SERVICE AND APPLICATION NOTES

H-13-02

Alternate Condensate Trap Replacement Kit 10C90

FIGURE 1

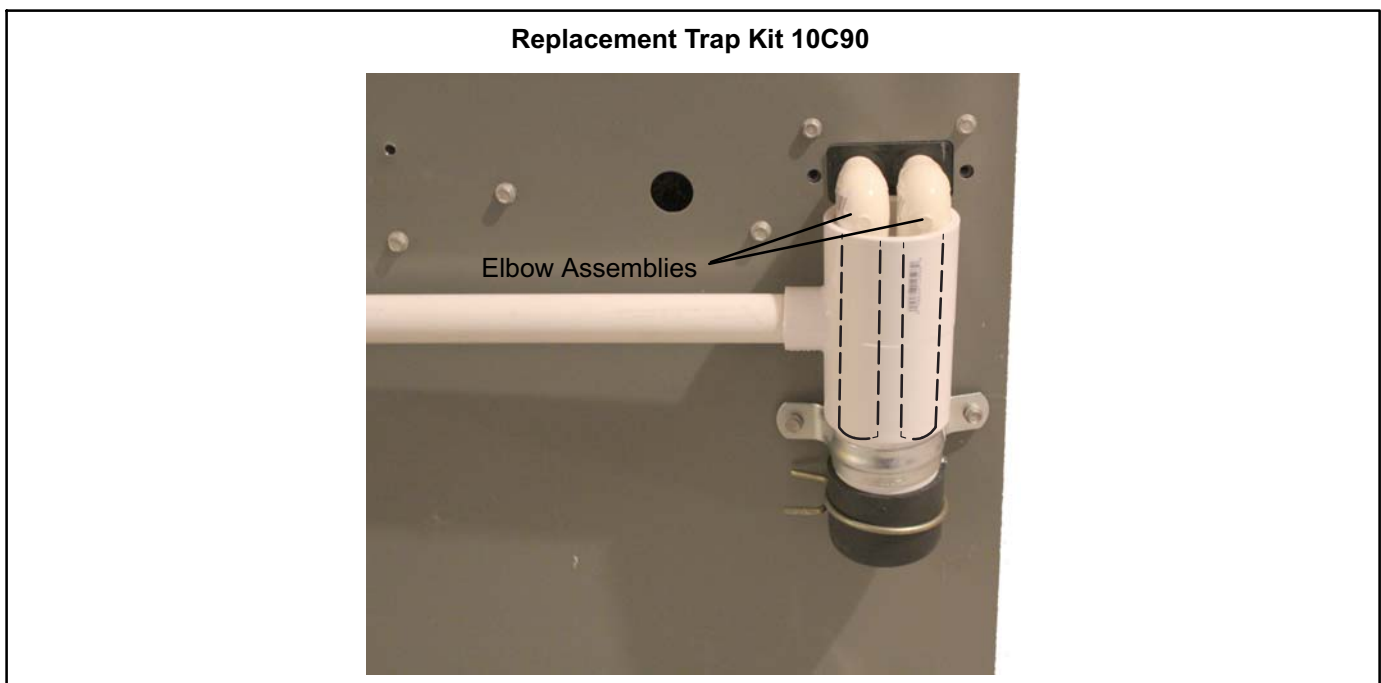
Lennox is introducing an alternate condensate trap replacement kit (10C90) for use with with G41UF, G43UF, G51MP, G61MP, G61MPV and G71MPP units installed in upflow and downflow applications ONLY. For G41, G43, G51MP, G61MP and G61MPV installed in horizontal applications use kit 61M35. For G71MPP units installed in horizontal applications use kit 39W98.

The 10C90 kit includes an open trap design which will not cause the unit to shut down if the drain or drain trap is blocked. The furnace will continue to operate in the case of a blockage. The drain termination must be visible to the homeowner and the homeowner must be aware of the importance of free flowing condensate during unit operation. This kit should not be used in areas where water from an overflowing trap could cause property damage.
